**DRAFT FINAL
TECHNICAL MEMORANDUM NO. 5**

**ADDENDUM TO FINAL PHASE I
RFI/RI WORK PLAN**

Revised Soil Gas Sampling Plan -- Original Landfill

**Rocky Flats Plant
Woman Creek Priority Drainage**

FIGURE 4

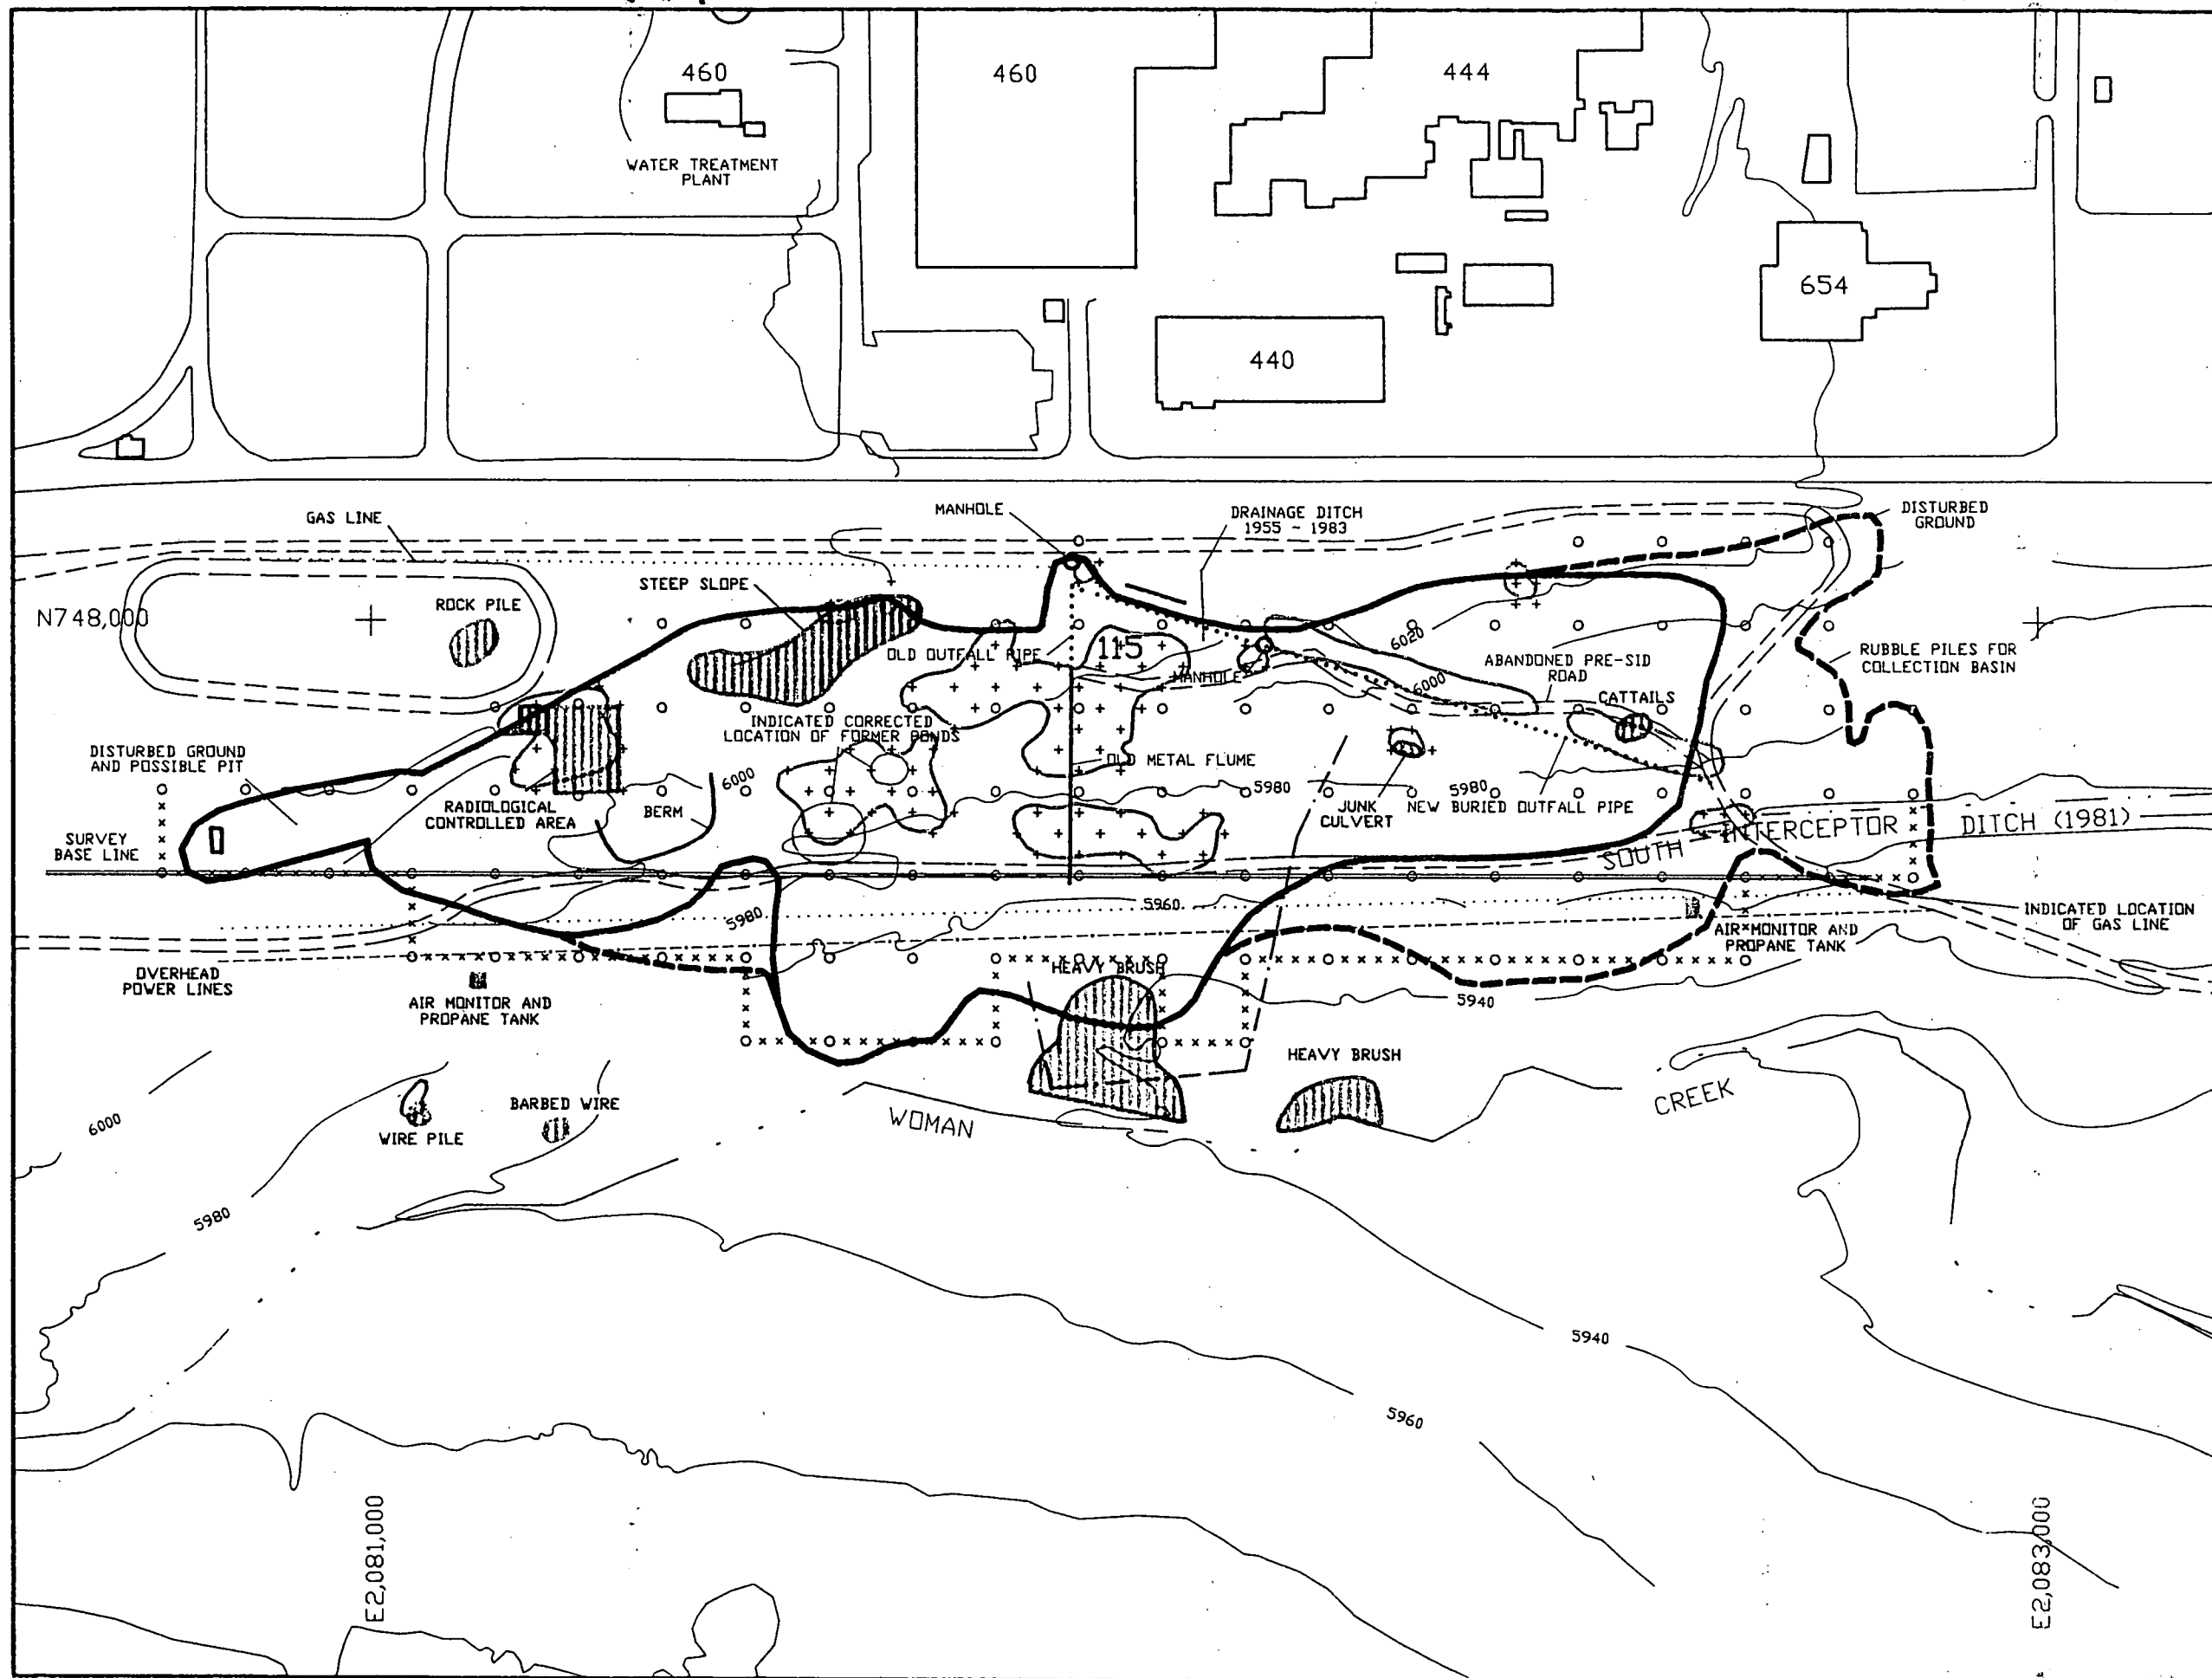
The downgradient perimeter of the landfill is proposed to be surveyed at 20-foot intervals in a single line (Figure 4). Based on the 10-foot radius of influence this spacing will provide an uninterrupted line of coverage for the downgradient perimeter.

In addition, the proposed coverage of magnetic anomalies consists of a 50-foot triangular grid. Magnetic anomalies that are too small to be covered by such a grid will be surveyed with a 25-foot grid. However, the magnetic anomalies occurring along the buried outfall pipe will not be included in the 50-foot or 25-foot grid because these magnetic anomalies have been determined by EG&G to be caused by the outfall pipe, not by buried waste.

Figure 4 presents the proposed primary and secondary soil gas sampling grids. Currently, the total number of soil gas samples to be collected is approximately 316: 104 samples at 100-foot centers, 96 samples at 50-foot centers, and 116 samples at 20-foot centers. An unknown quantity of tertiary sampling sites at 20-foot centers may be required if soil gas anomalies are detected.
